CONTEMPLATED CHANGE NOTICE

CCN NO: **09**
 CONTRACTOR: **Mr. Pat Newton**
Talco Building Innovations Inc.
 4728 Bank Street
 Ottawa ON K1T 3W7

PROJECT NAME: **225 Huntmar**
Ottawa, Ontario

CCN No: THREE (3) **Our Project Ref:** 15-610
Date: 29 May 2020 **Your Project Ref:** Enterprise Rent-a-Car

FIGURE: SKE-1
DATE: 29 May 2020
DWN BY: S.J.S.
JOB NO. 15-610

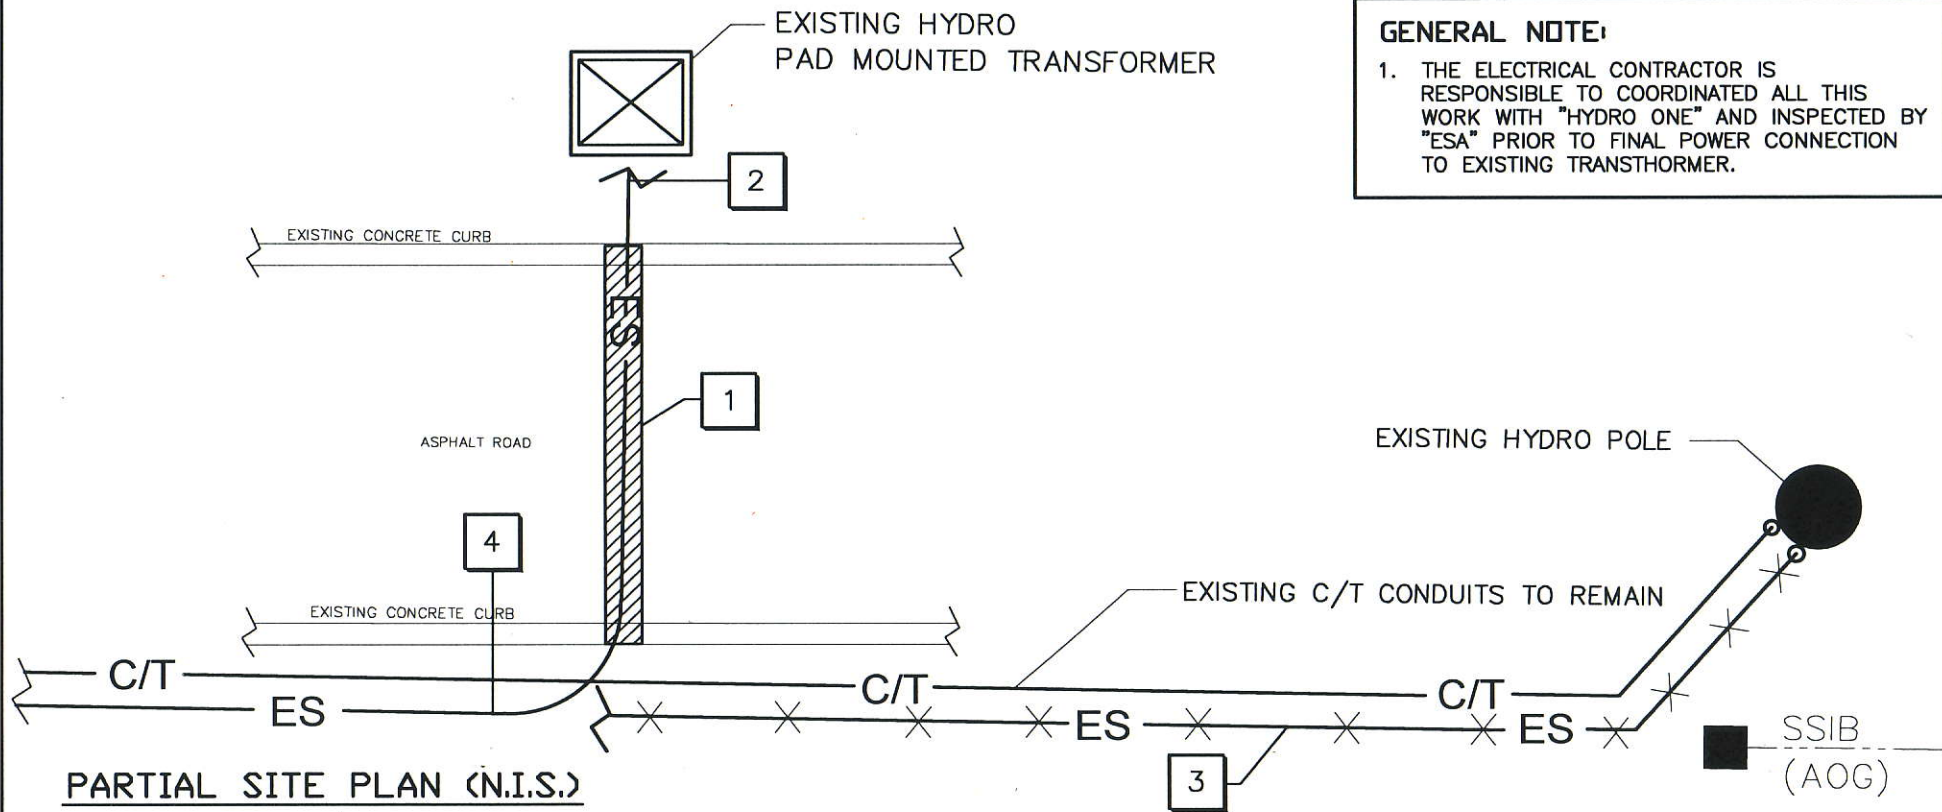
1. Attached SKE-1 Modifications to Enterprise Building Main Power Service.

1. PROVIDE NEW ROAD CUT FOR POWER TRENCH CABLES REFER TO INSTALLATION DETAIL DRAWING E-1 DETAIL #2. THE CONTRACTOR TO REINSTATE CURBS AND ASPHALT TO ORIGINAL CONDITION.
2. THE ELECTRICAL CONTRACTOR TO LEAVE EXTRA 3m OF CABLES FOR HYDRO FINAL POWER CONNECTIONS.
3. REMOVE CONCRETE DUCT BANK C/W DUCT SPACERS, REMOVE 2x4"Ø PVC CONDUITS AND REMOVE HYDRO POLE LATERAL POWER CABLES RUNS C/W GUARDS REFER TO DETAIL #3 E-1 DRAWING.
4. REMOVE POWER CABLES CONCRETE DUCT BANK FROM THIS POINT UP TO ENTERPRISE PARKING AREA.

CCN#3
MODIFICATIONS TO ENTERPRISE BUILDING ELECTRICAL POWER SERVICE
 ENTERPRISE RENT-A-CAR, KANATA
 225 HANTMAR DRIVE, OTTAWA, ONTARIO
